REGIONAL MUNICIPALITY OF OTTAWA-CARLETON
MUNICIPALITÉ RÉGIONALE D'OTTAWA-CARLETON

| SUBJECT/OBJET | AIRPORT PARKWAY/HUNT CLUB ROAD INTERCHANGE |

SUBJECT/OBJET **AIRPORT PARKWAY/
HUNT CLUB ROAD INTERCHANGE**

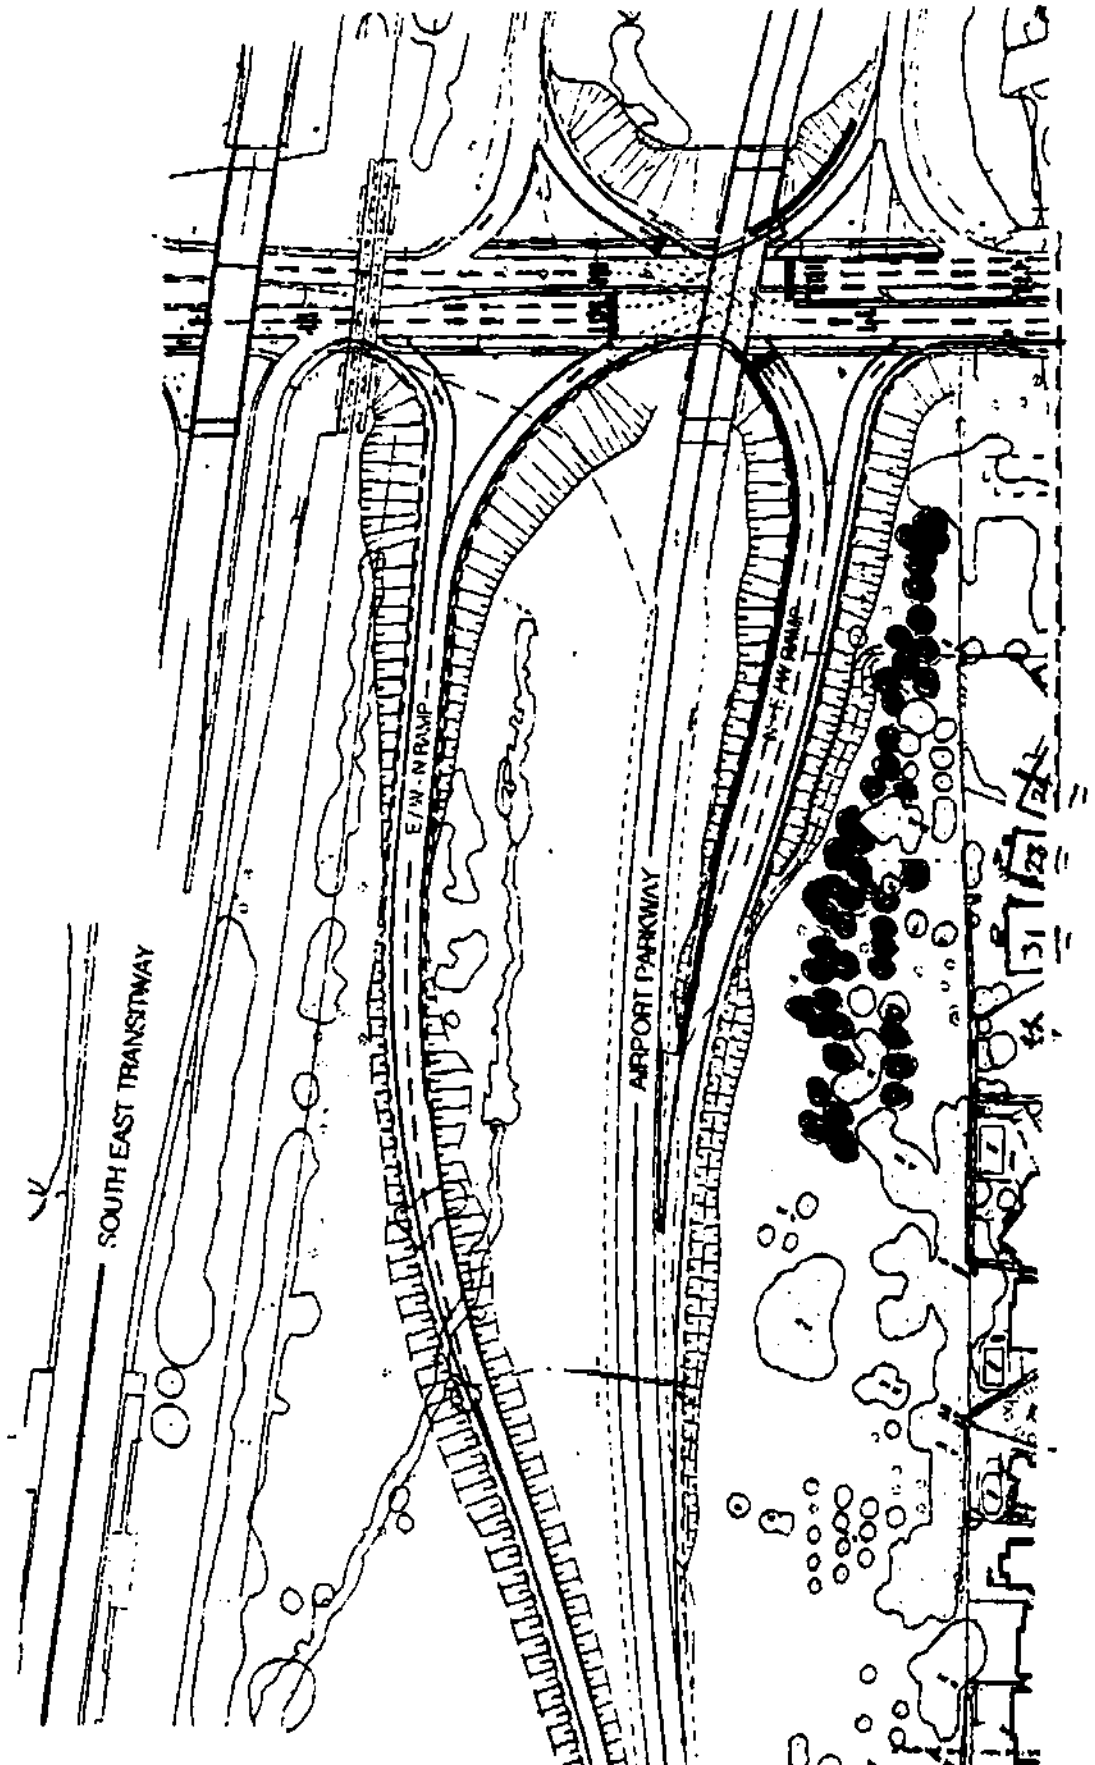
Our house was built before any decision was made to build the on and off ramps on the Airport Parkway in Hunt Club. We are concerned about the noise, the pollution and the view, due to the increase of traffic behind our backyard. In addition, the value of our property will depreciate as a result of the ramps. Our family, as well as homeowners in this neighborhood, has invested our lives savings into this house; therefore this issue concerns us very much.

As original residents of the Bankview Place community, we feel that it is legitimate for us to request improvements of your plan. We would like to suggest measures that would not result in a total loss of our investment. The regional council should allocate more money towards landscaping ventures, instead of merely the \$25,000 has been so far suggested. Rows of mature (6 to 8 feet) evergreen trees should be planted behind the properties within lots No.24 to No. 31. At this moment, there are many bare spots, and trees behind our house (No.31) are all deciduous. We believe that the only solution to this problem is to plant lots of evergreens behind our properties, in order to block the view of constant traffic rush.

I hope that you would seriously consider our proposal. We have enclosed a copy of a map that illustrates the trees we would like you to plant in rows to cover the whole property behind our houses.
